Access Compliance Report

Public Rights-of-Way

(Curb Ramps)

Intersection ID: 27680	Main Street: LANCASTER_HY	Cross Street: BALLANTYNE_COMMONS_PY	Location: SE
ADA ID: 3D456AACD80A	Ramp Type: Perp	Initial Pass/Fail: Fail	Overall Compliance: No
Severity Score: 21.25			
Codes/Mitigation Info/Possible Solution		Field Measurements/Component Compliance

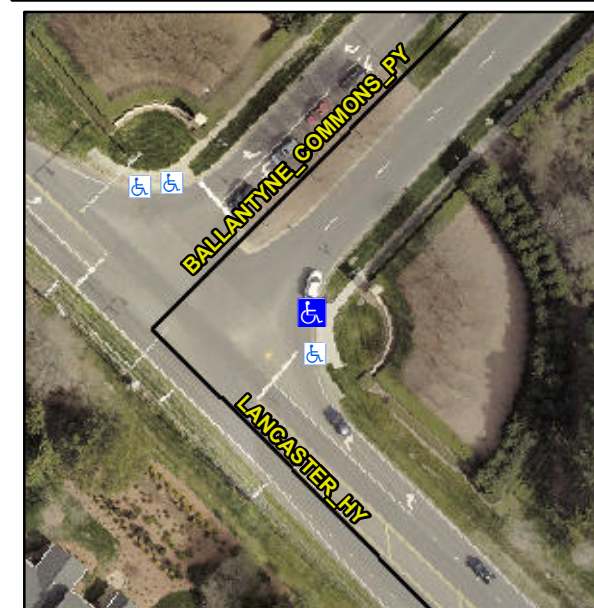
Not Found, R304.5.1, R304.5.3

Compliance	Description	Data	Compliance	Description	Data
N/A	Ramp Length (in)	51.0	Yes	Ramp Slope (%)	5.3
No	Ramp Width (in)	47.0	No	Ramp XSlope (%)	5.5
N/A	Flare Type LT	N/A	N/A	Flare Type RT	N/A
N/A	Flare Slope LT (%)	N/A	N/A	Flare Slope RT (%)	N/A
N/A	Flare Traversable LT?	N/A	N/A	Flare Traversable RT?	N/A
N/A	Landing Length (in)	N/A	N/A	DWS Provided?	N/A
N/A	Landing Width (in)	N/A	N/A	DWS Contrast?	N/A
N/A	Landing Slope (%)	N/A	N/A	DWS Length (in)	N/A
N/A	Landing X Slope (%)	N/A	N/A	DWS Full Width?	N/A
N/A	Landing Curb? (Y/N)	N/A	N/A	DWS Offset (in)	N/A
N/A	Shared Landing?	N/A			
N/A	Gutter Ponding?	N/A	N/A	Gutter Slope (%)	N/A
N/A	Gutter Lip Ht (in)	N/A	N/A	Gutter X Slope (%)	N/A
N/A	Painted X Walk1?	No	N/A	Painted X Walk2?	N/A
	X Walk 1 Direction	To NW		X Walk 2 Direction	N/A
N/A	X Walk 1 Width (in)	N/A	N/A	X Walk 2 Width (in)	N/A
	X Walk 1 Slope (%)	0.8		X Walk 2 Slope (%)	N/A
	X Walk 1 X Slope (%)	3.9		X Walk 2 X Slope (%)	N/A

Remove & Replace Entire Ramp.
